HN-235 DN-182 EN-74 FN-61

**DATE: 20 MARCH 1992**

## ONE-TIME INSPECTION/REWORK OF ENGINE AIR INLET AREA

Figure 1. Particle Separator Bypass Door Latch Cotter Pin Installation.

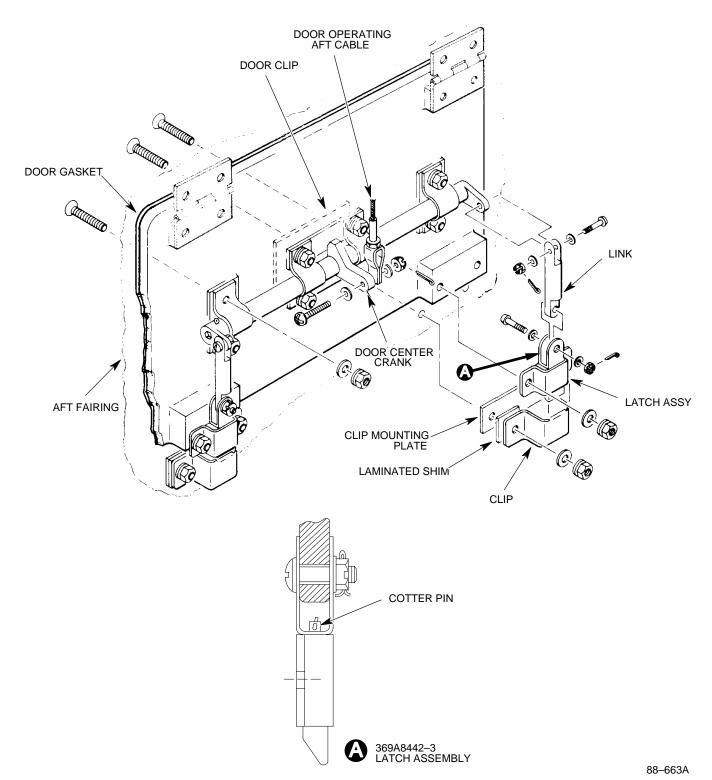
- a. Remove particle separator bypass door per the applicable maintenance manual.
- Inspect all latches, hinges, hardware, etc., for serviceability and security. Remove and replace any unserviceable components.
- c. Remove and inspect the bypass door latch and replace the latch retention cotter pin located inside the attach cable "U" clamp (see Figure 1).
- d. Replace the 369A8442-3 latch assembly if any of the following limits are exceeded:
- If cotter pin hole in the stem of the latch is elongated more than .080 inch in length.
- If cotter pin has worn into the surface of the cable attach "U" clip more than 1/2 the thickness of the clip (.025 inch deep).
- If the latch engagement faying surface is worn more that .050 inch below the original surface.
- e. Complete installation of particle separator bypass door.

Figure 2. Plenum Chamber Access Door Inspection/Rework.

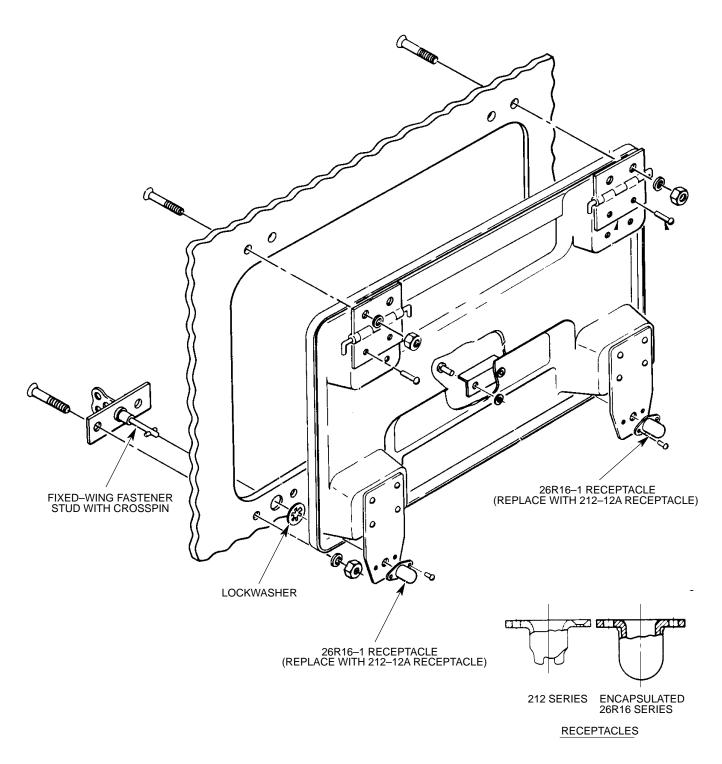
a. Remove two 26R16-1 encapsulated receptacles and replace with 212-12A receptacles. (Refer to Figure 2.)

b. Inspect fixed-wing fastener stud for serviceability and security paying particular attention to cross pin on stud and associated lockwasher (see Figure 2). Remove and replace any unserviceable components.

Figure 3. Replacement of Mist Eliminator Door Attaching Hardware.

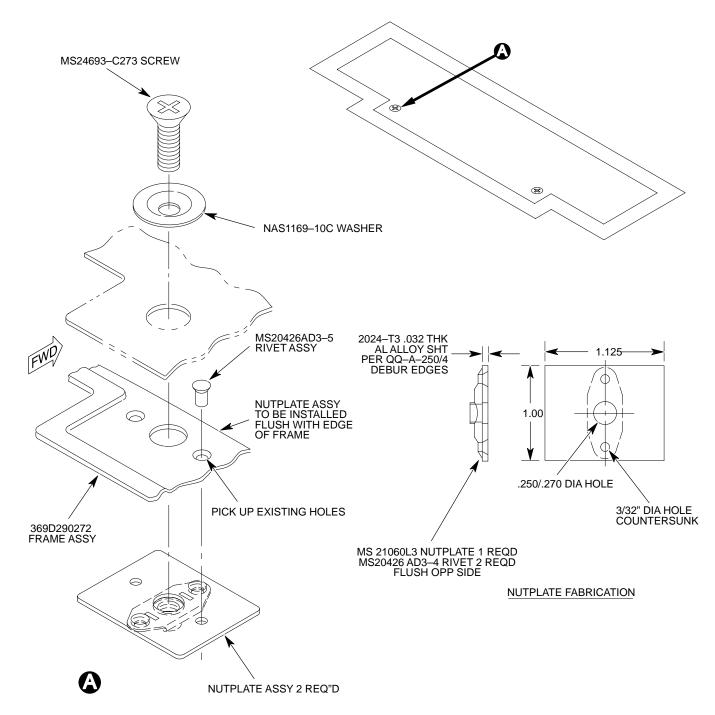
- a. Remove mist eliminator door per the maintenance manual.
- b. Remove the two 2700-7 studs, 2600-LW lockwashers and 26R16-1 receptacles (Ref. CSP-IPC-4, Section 71-10-10).
- c. Field fabricate two nutplate assemblies as shown in Figure 3.
- d. Install nutplate assemblies onto bottom side of 369D290272 frame assembly making sure to center nutplate assembly over existing hole in frame assembly as shown in Figure 3.
- e. Complete installation of mist eliminator access door using MS24693-C273 screw and NAS1169-10C washer (two each required).

Figure 4. Removal of Clips and Other Hardware From Plenum Chamber.

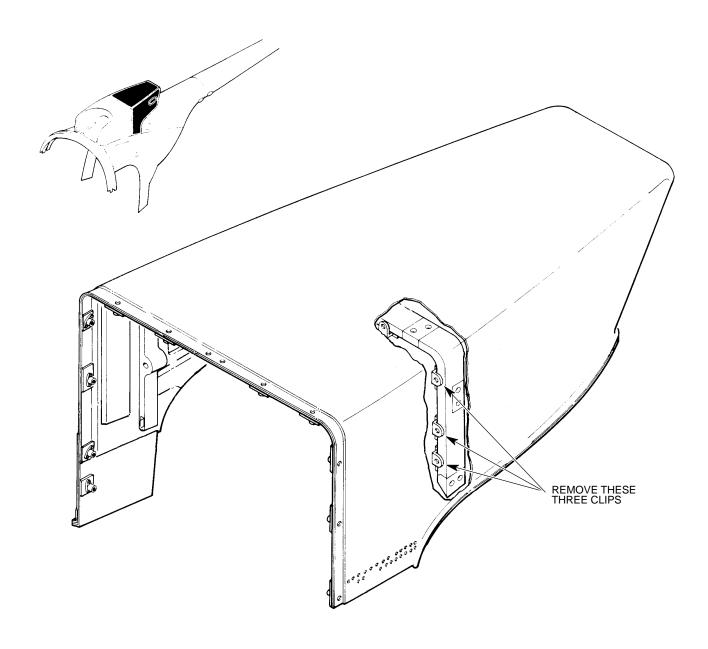
- a. Remove any unused clamps, clips, brackets or other hardware from the engine inlet plenum area.
- b. Remove three clips shown in Figure 4 (clips are bonded and covered with (1) layer of glass cloth). Carefully cut glass cloth around edges of clip and then remove clips. Trim cut edges of glass cloth.
- c. Inspect entire inlet plenum area hardware, hinges, cables, latches, etc., for serviceability and security. Remove and replace any unserviceable components.
